Wilder Park

Wilder Park is a very large sized neighborhood park that provides parking, walkways, picnic areas, grills, playground, mansion and Conservancy. The main issues at this park are abrupt transition are too high, gaps too wide, cross slope and running slope is too steep, parking space slopes are too steep, parking signage not at the center head, ramps slopes too steep, do not provide handrails or edge protection, clear floor space at benches are blocked, accessible routes are missing, picnic table do not provide accessible designs or provide accessible surfaces, grills do not provide clear ground space and are mounted too high, gutter slopes are too steep, curb ramp is missing, and dog waste bags are too high. **Please Note:** When a **UD** is indicated, this is a Universal Design (**UD**) recommendation to enhance accessibility. The **UD** recommendation is not required to meet the minimum accessibility standards but it would be encouraged. When engineered wood fiber is used, provide a regular maintenance of the surface to keep it in compliance with appropriate accessibility slopes. If used in this report, the letters, **AFF** stand for above finished floor.

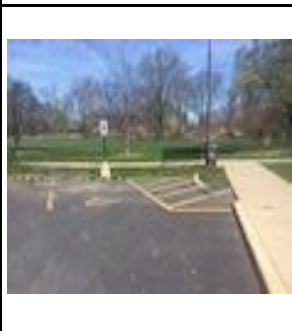
Photo	Barrier	ADAAG/IAC	Solution	Priority	By Whom	Projected Cost	Projected Date	Action Taken
	The ramp on the other side of the mansion entrance toward the tennis courts has a running slope too steep at up to 9.4% for 52 feet.		See Note Below			See Note Below		
	The ramp on the other side of the mansion entrance toward the tennis courts does not provide handrails	ADAAG 403.3	Remove and regrade section to provide an accessible route with a running slope no greater than 5% and an cross slope no greater than 2%. Option: Since this area is equal to a ramp slope, adding only handrails on both sides would be acceptable. See ADAAG 405.8	1		\$ 11,000.00		
	The accessible parking at the tennis courts has a running slope too steep at 6.1% and a cross slope too steep at 4.1%.	ADAAG 502.4	Regrade the parking spaces to be no steeper than 2% in all directions.	1		\$ 1,275.00
